pCLAMP™ Electrophysiology Data Acquisition and Analysis Software

Software Release Notes

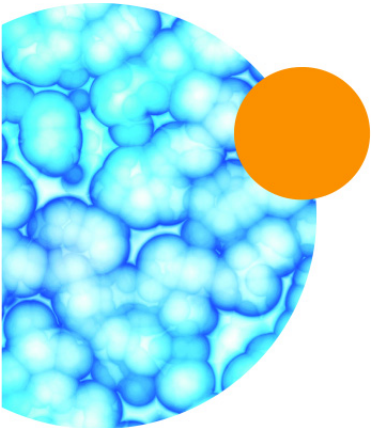
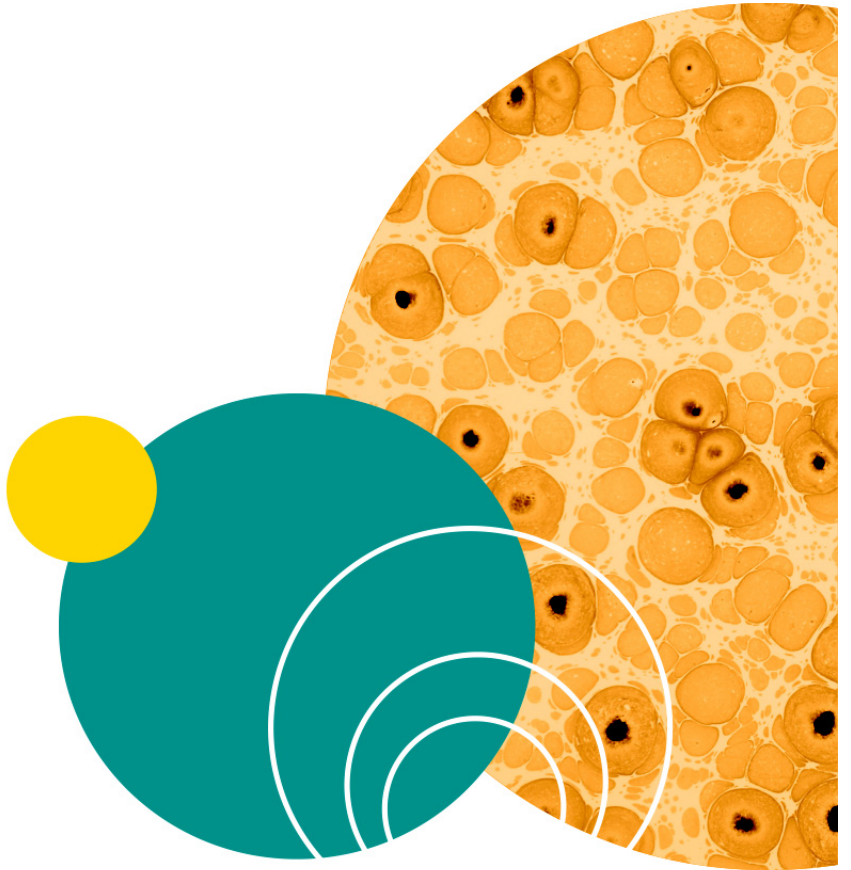
The pCLAMP™ Electrophysiology Data Acquisition and Analysis Software Version 10.7 update is a minor release. The following is a summary of the changes incorporated in this update as compared to version 10.6.1, the last general release of the pCLAMP Software.
